Illinois Tollway Standard Drawing Revisions

Section C	Guardrail / Median Barrier	
	Standard	**Modification Summary** **Effective: 03-31-2016**
	All	**The electronic (pdf) version of the Standard Drawing are now made searchable (text).**
	C1	**Galvanized Steel Plate Beam Guardrail**

CONCRETE MEDIAN BARRIER TRANSITION, TYPE V-F AT BRIDGE PIERS

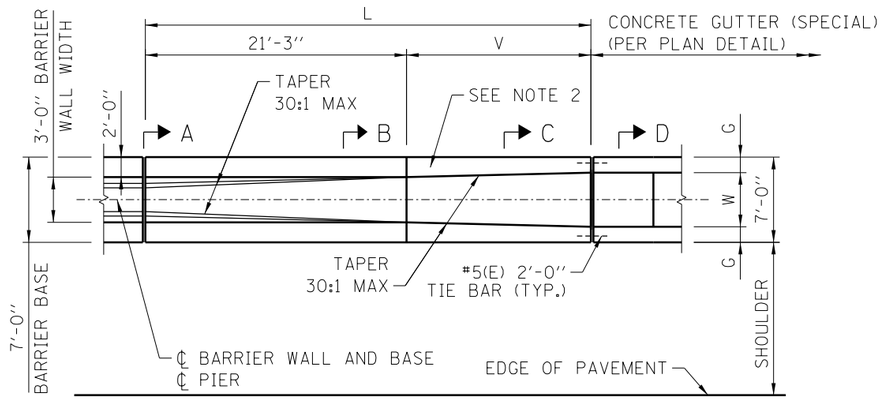
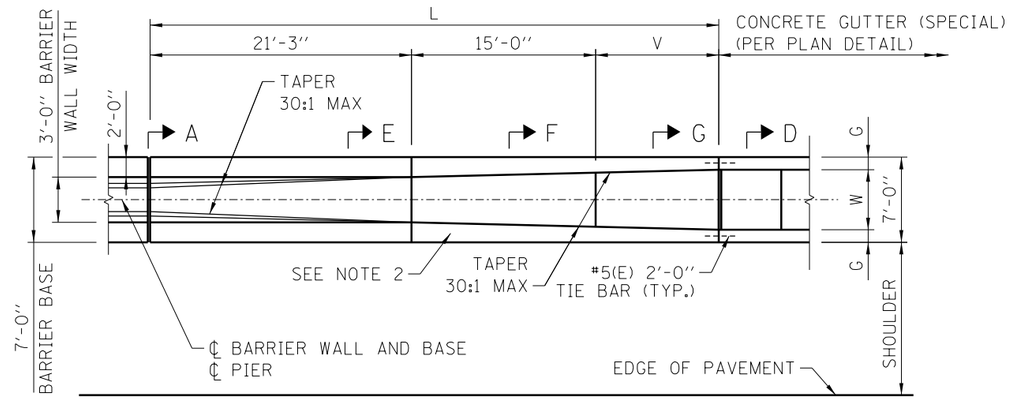
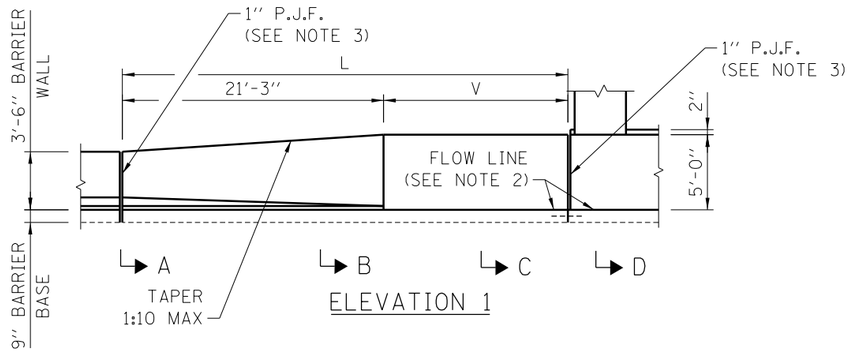
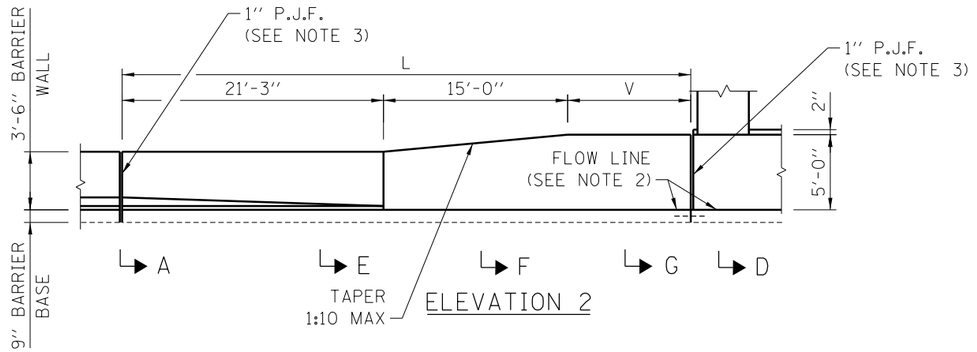
C13	**Concrete Median Barrier Transition, Type V-F at Bridge Piers**
		Combined Notes 1 & 2 and renumbered Notes.
		Note 3 (former Note 4). Revised expansion joint sealant note to match structure detail.
		Removed Tie Bars in Section D-D. Removed backer rod from sides and beneath base in Section A-A.
	C14	**Concrete Median Barrier Transition, Type V at Bridge Piers**
		Aligned Plan and Elevation views. Added ditch to Elevation view. Re-arranged Notes and Sections.

DATE	REVISIONS
11-01-2012	MODIFIED MEDIAN BARRIER TRANSITION.
3-31-2014	MODIFIED BARRIER BASE.
3-11-2015	MODIFIED MEDIAN BARRIER TRANSITION.
3-31-2016	MODIFIED NOTES

CONCRETE MEDIAN BARRIER TRANSITION, TYPE V AT BRIDGE PIERS

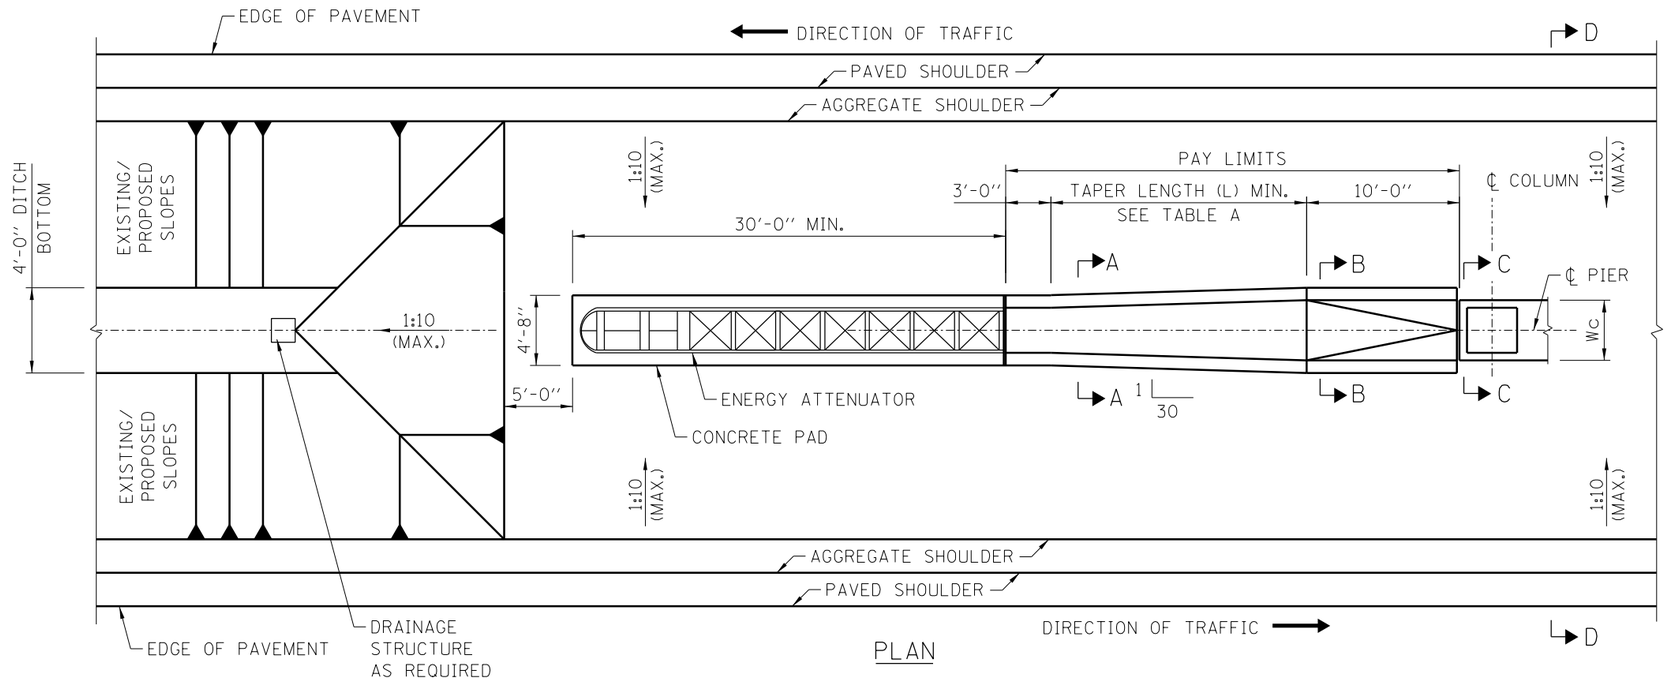
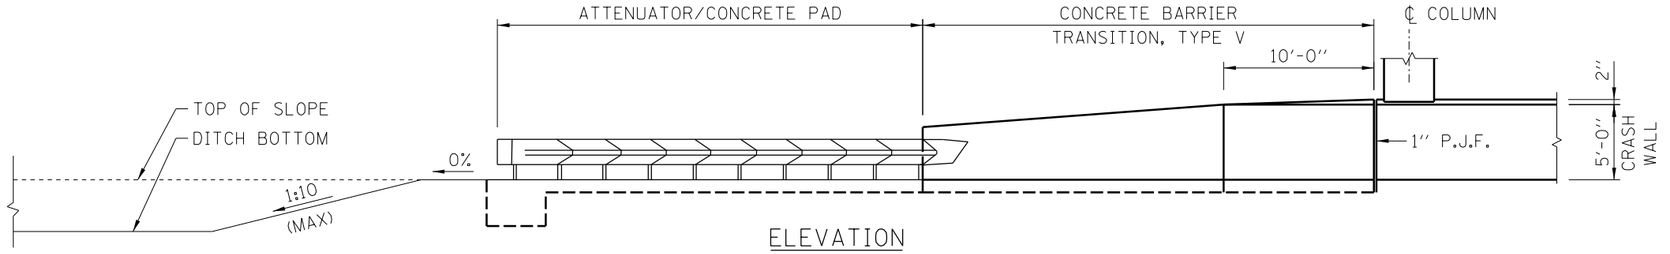
DATE	REVISIONS
3-11-2015	REVISED NOTES
3-31-2016	ADDED SEC. B-B TOP, DITCH ELEV. VIEW AND REVISED NOTE 3
